Access Compliance Report

Public Rights-of-Way

(Curb Ramps)

Intersection ID: 8186	Main Street: CINDERELLA_RD	Cross Street: YUMA_ST	Location:	N
ADA ID: FB8C43B8F4D7	Ramp Type: Directional1	Initial Pass/Fail: Fail	Overall Compliance: No	Severity Score: 46.25

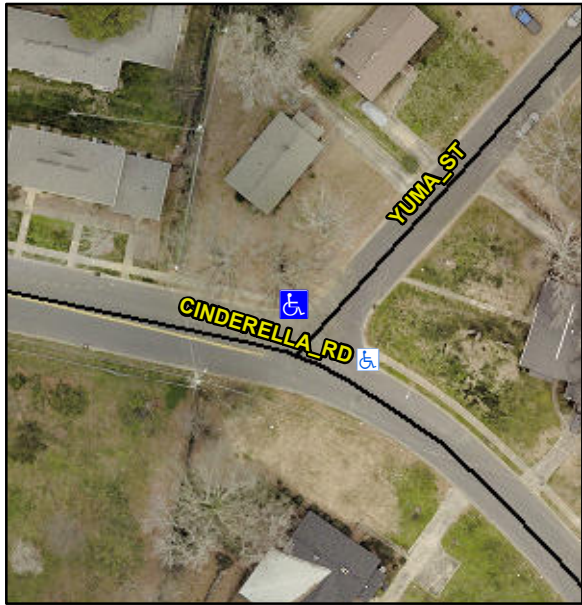
Codes/Mitigation Info/Possible Solution			Field Measurements/Component Compliance					
	Possible Solutions:		Compliance	Description	Data	Compliance	Description	Data
	Remove & Replace Entire Ramp.		N/A	Ramp Length (in)	61.0	N/A	Grade Break?	N/A
			No	Ramp Width (in)	37.5	N/A	Grade Break Slope (%)	0.0
			No	Ramp Slope (%)	9.6	N/A	Grade Break XSlope (%)	0.0
			No	Ramp XSlope (%)	9.5			
			N/A	Flare Type LT	N/A	N/A	Flare Type RT	N/A
			N/A	Flare Slope LT (%)	N/A	N/A	Flare Slope RT (%)	0.0
			N/A	Flare Traversable LT?	N/A	N/A	Flare Traversable RT?	N/A
			N/A	Landing Length (in)	0.0	N/A	DWS Provided?	N/A
			N/A	Landing Width (in)	0.0	N/A	DWS Contrast?	N/A
Surveyor Notes:		N/A	N/A	Landing Slope (%)	0.0	N/A	DWS Length (in)	N/A
		N/A	N/A	Landing X Slope (%)	0.0	N/A	DWS Full Width?	N/A
PROW/ADA:		R304.5.1, R304.2.2, R304.5.3	N/A	Landing Curb? (Y/N)	N/A	N/A	DWS Offset LT (in)	N/A
			N/A	Shared Landing?	N/A	N/A	DWS Offset RT (in)	N/A

N/A	Gutter Ponding?	0.0	N/A	Gutter Slope (%)	N/A
			N/A	Gutter Lip Ht (in)	0.0	N/A	Gutter X Slope (%)	N/A
			N/A	Painted X Walk1?	No		Road Slope (%)	1.8
				X Walk 1 Direction	To SE		Road X Slope (%)	0.5
				X Walk 1 Width (in)	N/A		Clear Space?	N/A
				X Walk 1 Slope (%)	1.8	N/A	Clear Space to XWalk (in)	N/A
				X Walk 1 X Slope (%)	0.5	N/A	Storm Grate/Utility Hazard?	N/A
			N/A	Ramp inside XWalk1?	N/A		Storm Grate/Utility Type	
			N/A	Any Obstructions?	N/A			N/A
				Obstruction Type		Yes	Surface Condition? (G/P)	Good
					N/A	N/A	Curb Slope (%)	15.6
Total Cost:		\$ 1600.00
